**TOWN OF WINTER PARK  
BOARD OF ADJUSTMENT  
Tuesday, September 9, 2025 8:00 AM  
Immediately following Planning Commission**

**RE** PUBLIC HEARING: Building Height Variance – 78641 US Highway 40 (PLN25-038)

## **Variance Request - Building Height – 78641 US-40**

Figure 1 (3D Model of proposed variance request – all portions above the blue are in excess of the 55 FT height limitation as outlined in the UDC)

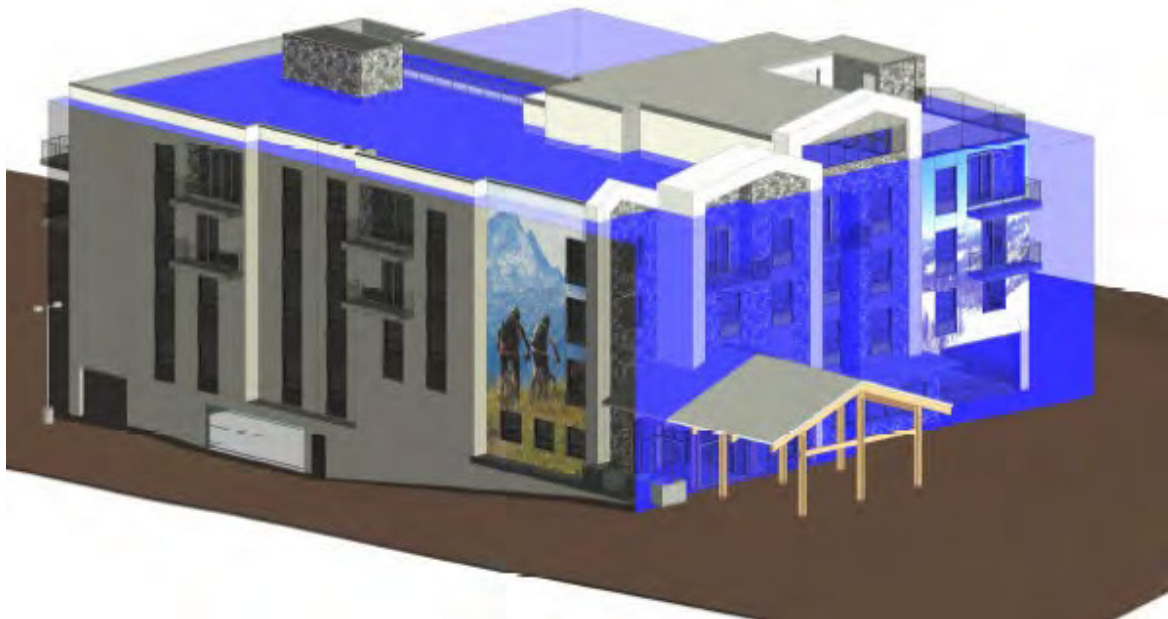
Staff finds it important to note that the portions of the structure proposed to exceed the maximum building height are limited in nature. The uppermost level is designed as a rooftop café and courtyard, with only enclosed stairwells and accessory structures extending above the roofline (Figure 1). This request is therefore distinguishable from a typical height variance involving a fully enclosed building. While the applicant is seeking an additional 13 feet of height allowance, only a minor portion of the structure will extend beyond the Town's 55-foot maximum height standard.

The applicant has also submitted three-dimensional elevation drawings depicting the proposed structure as if the "height averaging" method were utilized to calculate building height (Figure 2). These renderings illustrate that only a limited portion of the building would exceed the 55-foot threshold under that approach. Staff notes that "height averaging" is not an adopted method of measurement in the Town Code; however, it is currently under consideration as part of broader discussions regarding potential amendments to the height measurement standards. Notwithstanding these considerations, the subject variance must be reviewed under the Town's current code provisions and evaluated against the established variance approval criteria, as outlined below.

Figure 2: (This figure incorporates ‘height averaging’. If height averaging were a component of our UDC then all portions of the structure above the green area would exceed the 55 ft height limitation)
